# SERVICE BULLETIN

## ENGINE - POWER PLANT - EEC AND IGNITION SUPPLY HARNESS, CLIPPING POINTS - CHANGES TO - CATEGORY CODE 4 - MOD.ENG-71-0035

# V2500-ENG-71-0035

Location of Clipping Points 0819 and 0821  
Fig.1

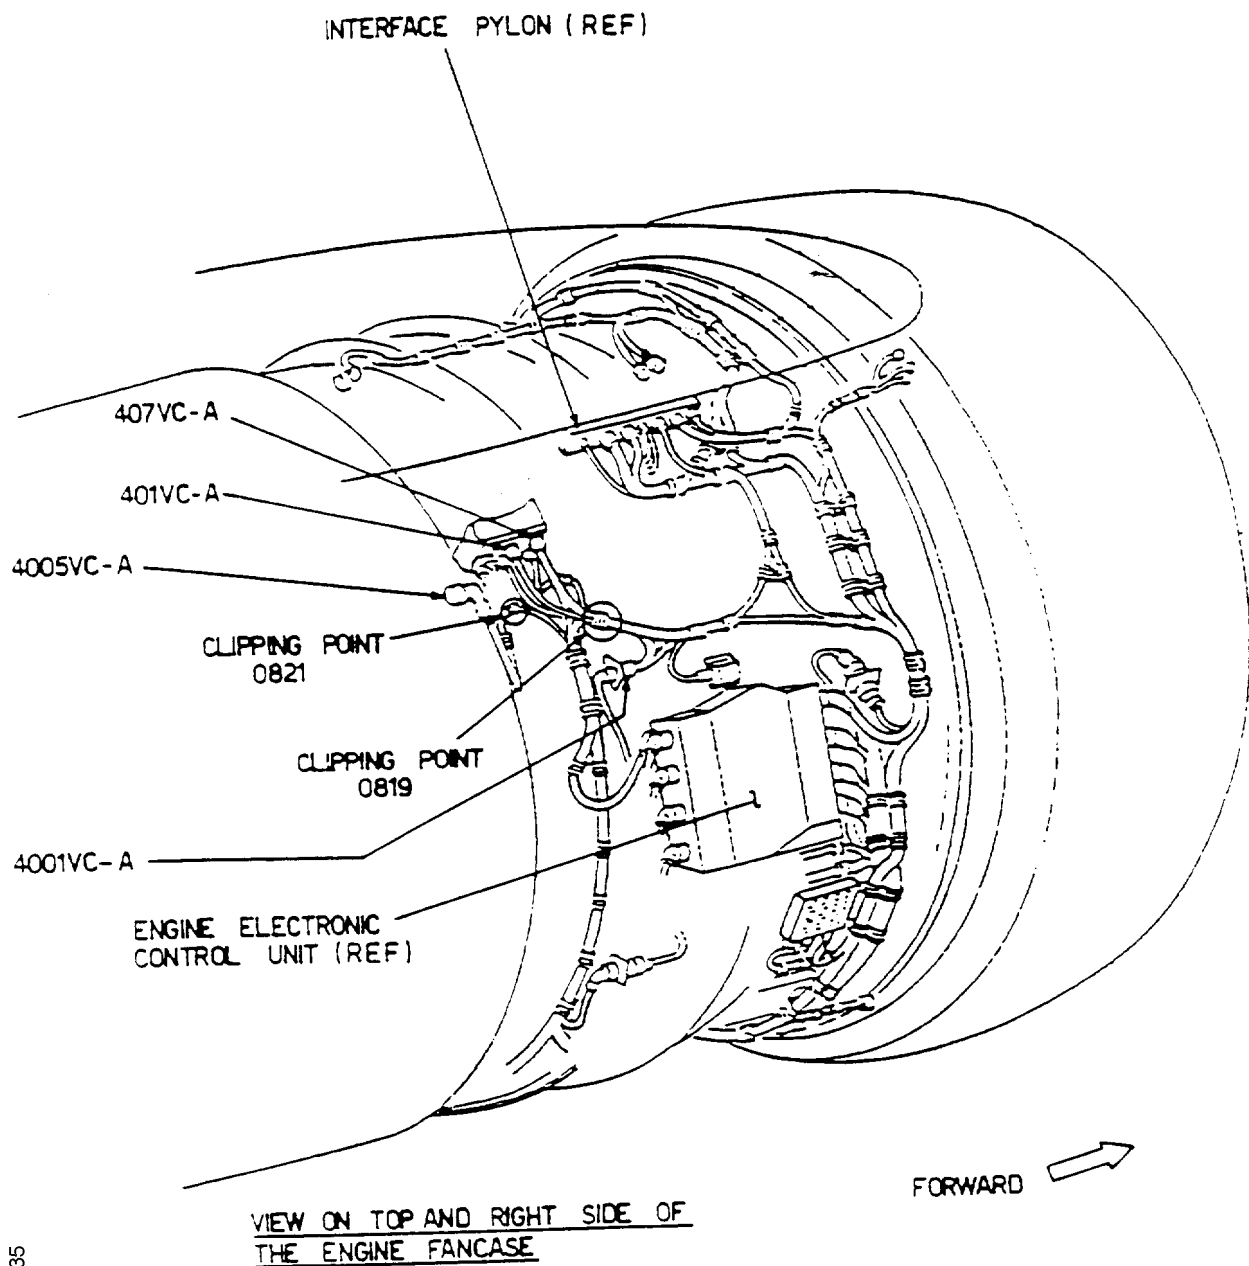
- (1) Open the fan cowl doors as specified in the V2500 Aircraft Maintenance Manual, Task 71-13-00-010-010.
- (2) Find the 0819 and 0821 clipping points on the engine fancase. (Refer to Figure 1.)

CLIPPING POINT 0819CLIPPING POINT 0821Change of Clipping Points 0819 and 0821  
Fig.2

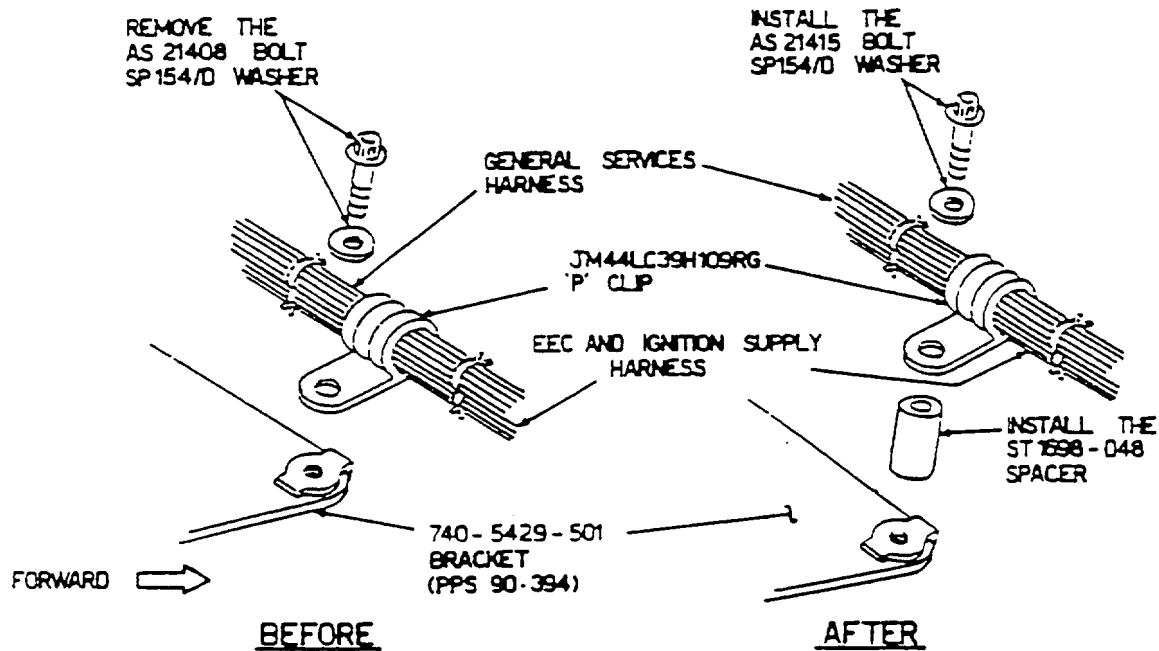
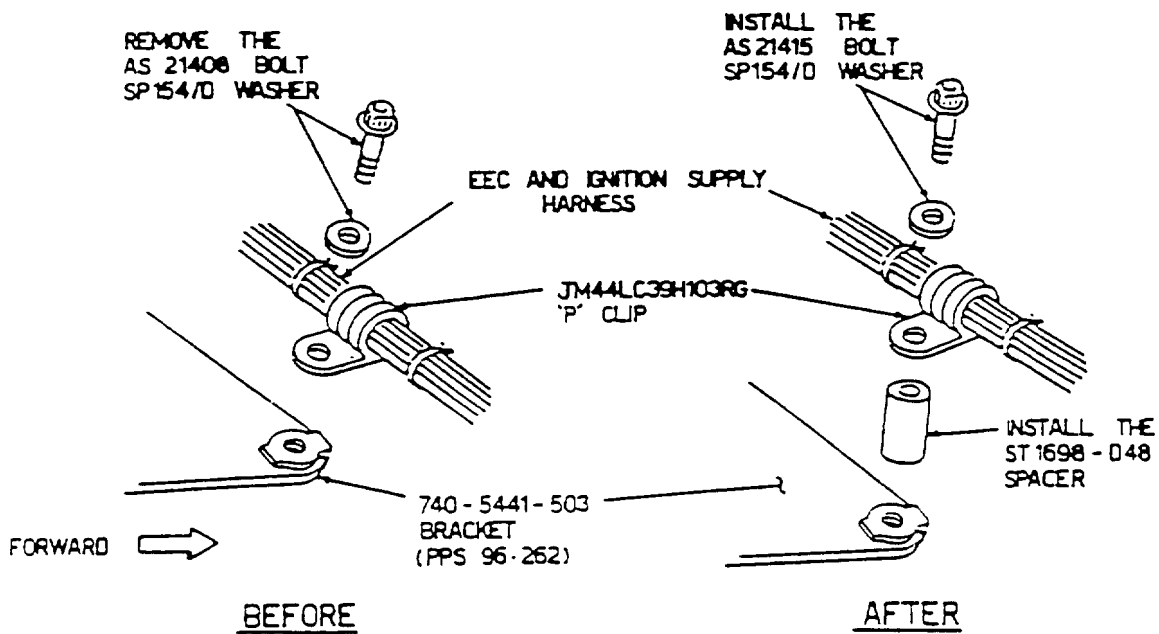
A spacer is installed at clipping points 0819 and 0821 on the engine fan case. The bolt at the clipping points must also be replaced as a result of the installation of the spacers. This modification will increase the clearance between the EEC and ignition supply harness and the engine flanges.

- (1) Change clipping point 0819 as follows: (Refer to Figure 2.)
  - (a) Remove the AS21408 bolt, the SP154/D washer which attach the JM44LC39H109RG 'P' clip to the 740-5429-501 mounting bracket. Discard the bolt.

- (b) Assemble the clipping point to the 740-5429-501 mounting bracket as shown in the after configuration of Figure 2. Install the ST1698-D48 spacer and attach the JM44LC39H109RG 'P' clip to the bracket with an AS21415 bolt and an SP154/D washer.

- (c) Torque the AS21415 bolt to 40 lb-in. (4.52 N.m) as specified in the V2500 Aircraft Maintenance Manual, Task 70-23-11-911-010.
- (2) Change clipping point 0821 as follows: (Refer to Figure 2.)

- (a) Remove the AS21408 bolt and the SP154/D washer which attach the JMM44LC39H103RG 'P' clip to the 740-5441-503 mounting bracket. Discard the bolt.

- (b) Assemble the clipping point to the 740-5441-503 mounting bracket as shown in the after configuration of Figure 2. Install the ST1698-D48 spacer and attach the JM44LC39H103RG 'P' clip to the bracket with an AS21415 bolt and an SP154/D washer.

- (c) Torque the AS21415 bolt to 40 lb-in. (4.52 N.m) as specified in the V2500 Aircraft Maintenance Manual, Task 70-23-11-911-010.
